ADDENDUM NO. 1

**Water & Wastewater Improvements
Graham Cave State Park
Danville, Missouri
Project No. X2321-01**

Bidders are hereby informed that the construction Plans and/or Specifications are modified as follows:

3 E-102 ELECTRIC RISER DIAGRAM
NO SCALE

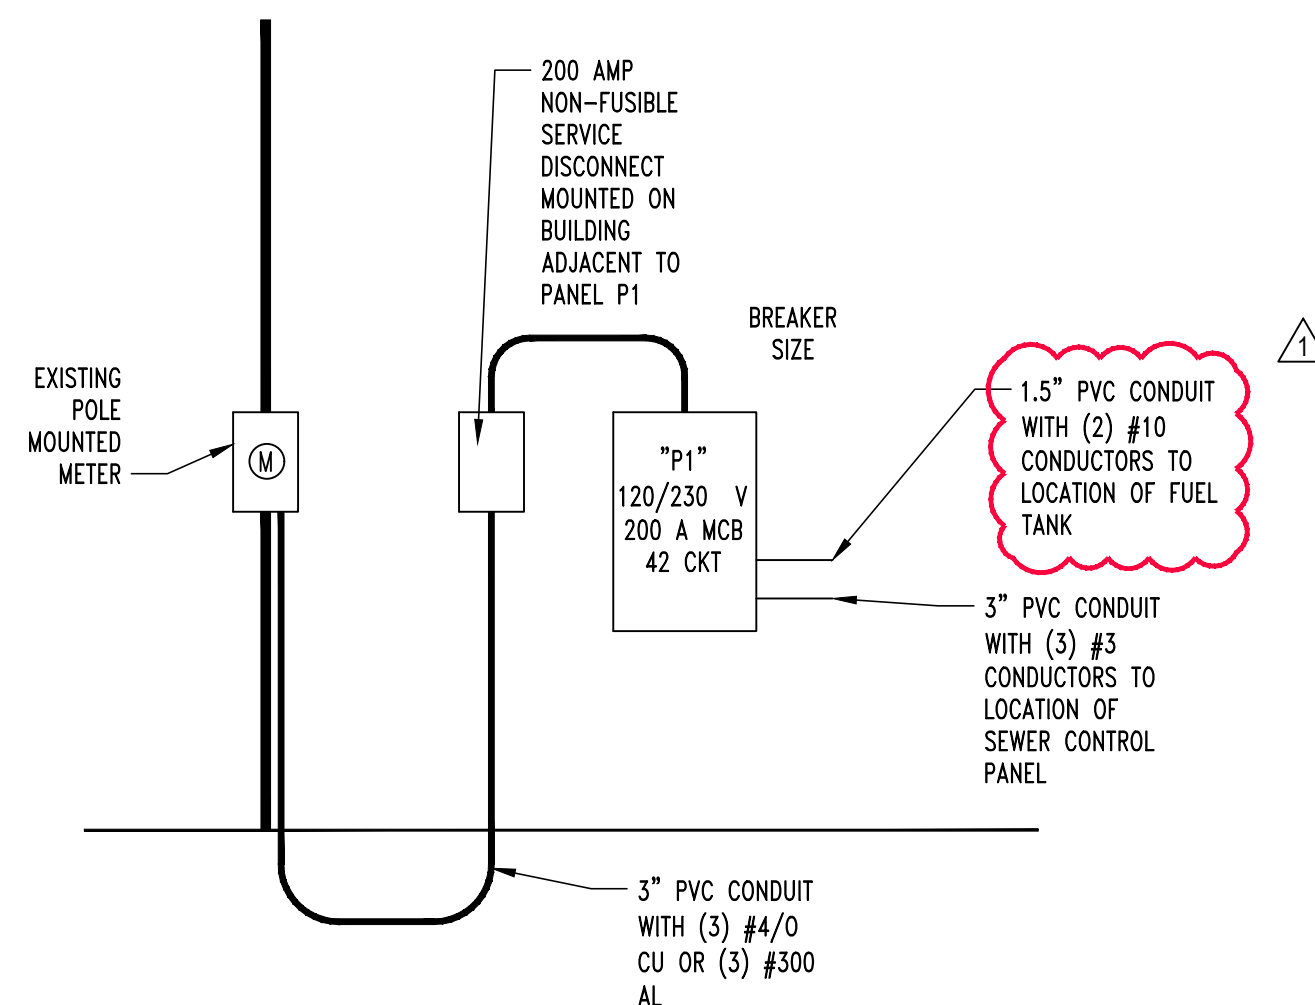
10. Sheet E-102
 - a. Circuit added for fuel pumps.
 - b. Riser diagram amended to show fuel pump circuit and conduit and wiring from panel to fuel tank.

- c. See attached revised drawing.
